**SUBJECT: COMANCHE PEAK NUCLEAR POWER PLANT, UNITS 3 AND 4
DOCKET NUMBERS 52-034 AND 52-035
RESPONSE TO REQUEST FOR ADDITIONAL INFORMATION NO. 4312 AND 4314**

Response to Request for Additional Information No. 4312 (CP RAI #144)

Response to Request for Additional Information No. 4314 (CP RAI #147)

Figure 1-1 Cross-Section Location Map

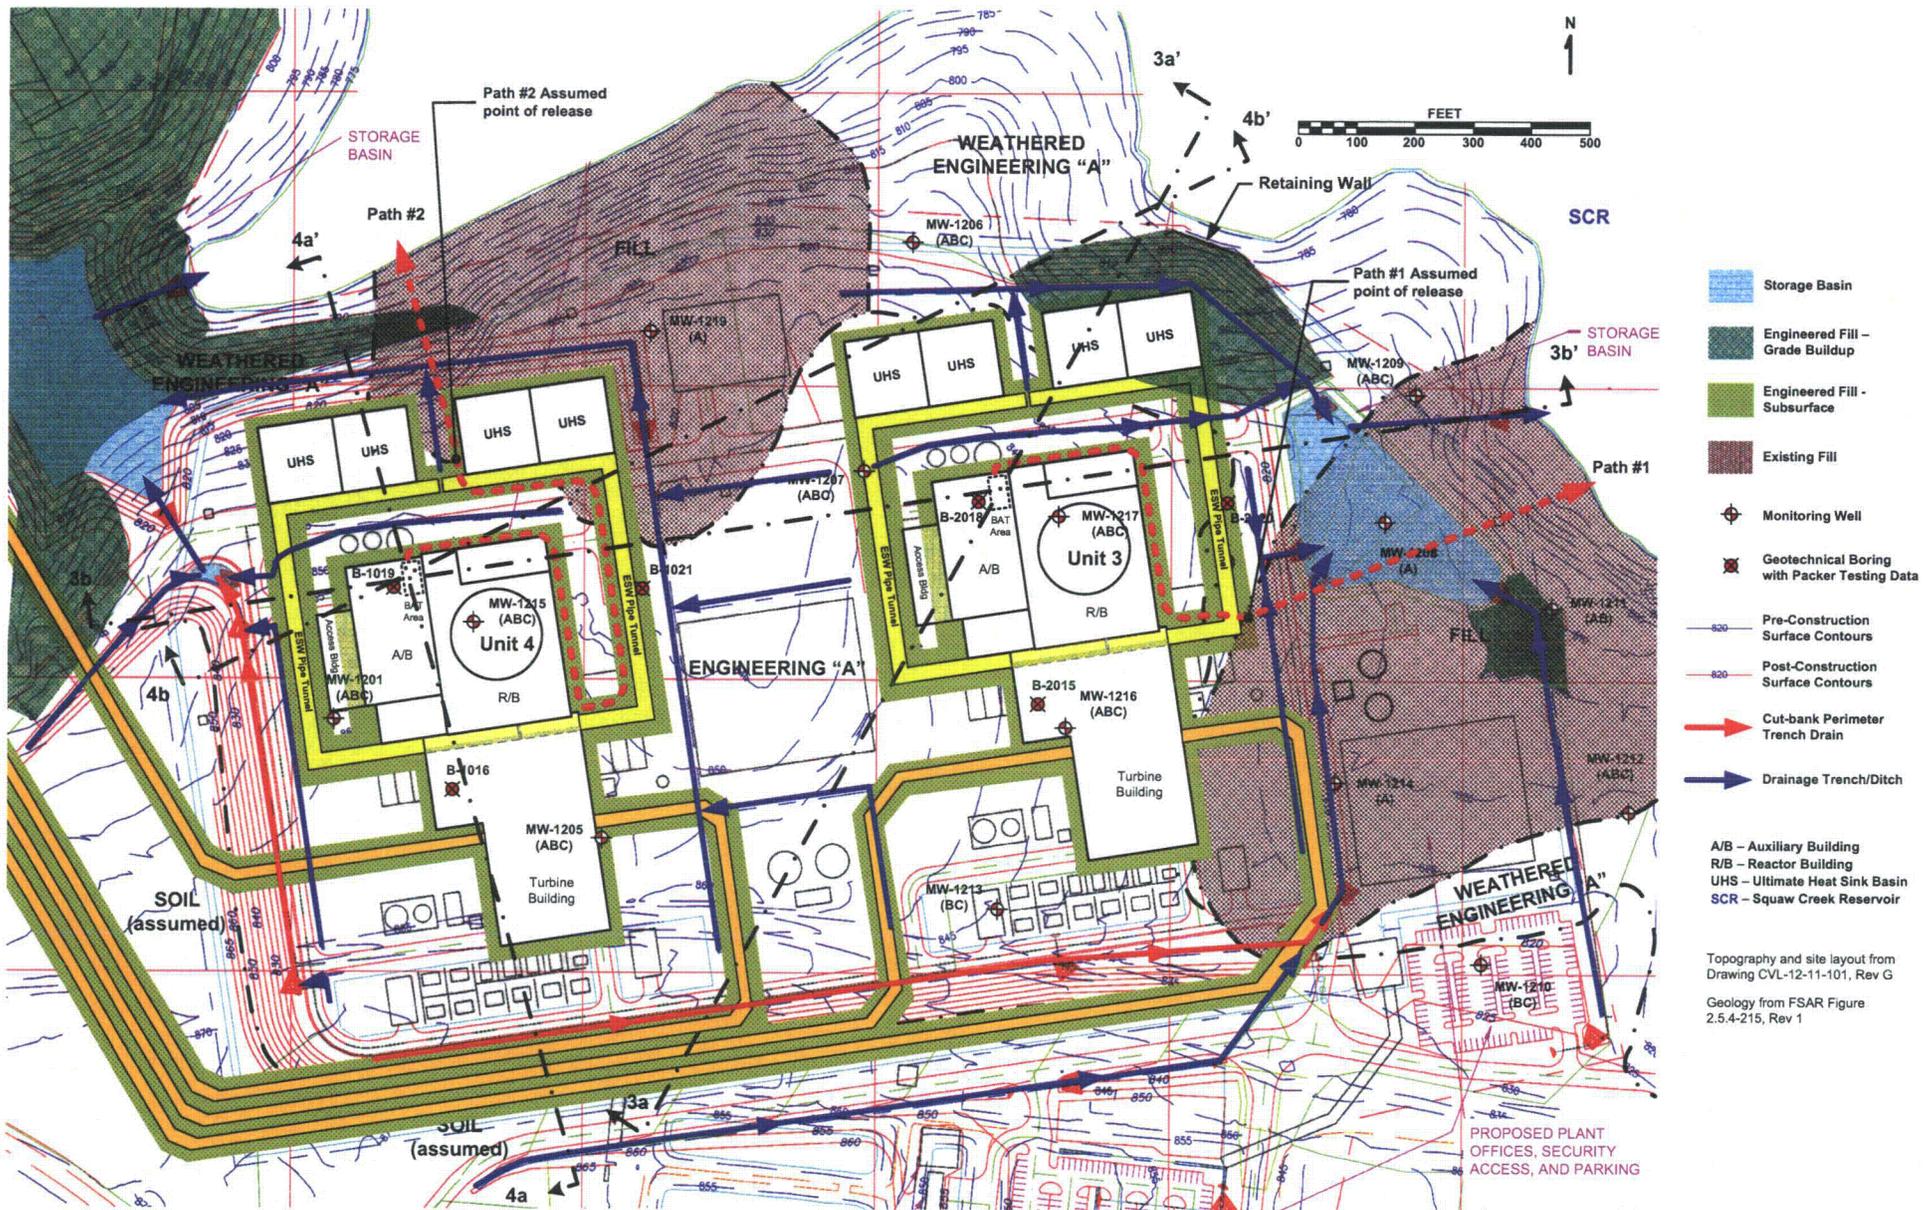
In order to make its safety determination based on adequate characterization of the site that depicts the post-construction scenario adequately, the NRC staff requests that the applicant provide the following information.

- 1) A qualitative description of the construction related impacts that could affect site hydrology including maps at a legible scale, sufficiently detailed engineering design information on drainage systems and a description of conservative measurements or estimates of hydrologic parameters. This information should be of sufficient detail to support an analysis of the impact of site modifications on site hydrologic processes such as infiltration, surface runoff, groundwater levels, hydraulic gradients and flow paths.
- 2) A conservative quantitative analysis that demonstrates that the estimated maximum operational groundwater level complies with the US-APWR Design Certification Document.

Soils and the upper surface of engineering layer "A" will be removed from the entire plant site, with cut backs surrounding the site to the south and west as illustrated in both FSAR Figures 2.4.2-202 and 2.5.5-204. At the base of the grading cut backs, a trench drain will be installed to divert water (stormwater or groundwater seepage) away from the site to the stormwater collection ponds to the east and west of the plants. Additional drainage swales will be installed throughout the site to drain stormwater away from the buildings.

Once the soils (groundwater A-zone) are removed from the site, a topographically higher soil horizon will remain to the south and west of the power block areas. Although this higher soil horizon may provide a recharge source for those portions of the engineering layer "A" that remain surrounding the engineered fill within the plant site, the final site grading and drainage plan, illustrated in both FSAR Figures 2.4.2-202 and 2.5.5-204, shows the base of the drainage system along the southern and western boundaries of the plant site to be less than 820 ft msl. The northern and eastern boundaries of the site slope directly from the plant grade level of 822 ft msl towards Squaw Creek Reservoir (SCR), with normal pool elevation at 775 ft msl, or the stormwater holding ponds, with elevations at approximately 800 ft msl. This relationship is also depicted in Figure 1-1.

Groundwater recharge from the remaining soils into engineering layer "A" and the engineered fill surrounding the embedded portions of Units 3 and 4 is constrained by the base of the trench drain. With the exception of small amounts of landscaping, no soils would remain in the plant site which would be capable of recharging the remaining engineering layer "A". Site drainage is designed to remove stormwater with no pooling, thus preventing areas of recharge within the plant site.

Based on the interception of infiltrating perched groundwater or stormwater by the site drainage system, the maximum groundwater potentiometric surface at the site would be found at the base of the trench drain along the southern and western cut banks, equivalent to a maximum elevation of 820 ft msl. No constraining boundaries exist on the northern and eastern plant boundaries prior to the lower pool elevations of SCR. One retaining wall is to be constructed along the shore of SCR north of the Unit 3 UHS basins; however, the retaining wall is of limited extent and the top of the retaining wall is approximately 800 ft msl, well below the DCD maximum groundwater elevation. Two stormwater retention basins are also to be constructed to the east of Unit 3 and the west of Unit 4; however, the overflow elevations will be less than 810 ft msl, preventing accumulated stormwater from recharging the subsurface groundwater above the DCD maximum groundwater elevation.

Determination of the exact maximum groundwater elevation at the power block locations will be difficult, if not impossible, to calculate. However, based on the above discussion, use of the constrained maximum groundwater elevation at the cut back trench drain base (maximum 820 ft msl) between 300 feet (west) to 700 feet (south) from CPNPP Units 3 and 4 and the removal of recharge sources in the plant location (groundwater A-zone) conservatively proves the groundwater levels at the power block embedded foundations will not exceed the DCD required maximum groundwater elevation of 1 ft below the site grade elevation (822 ft msl).
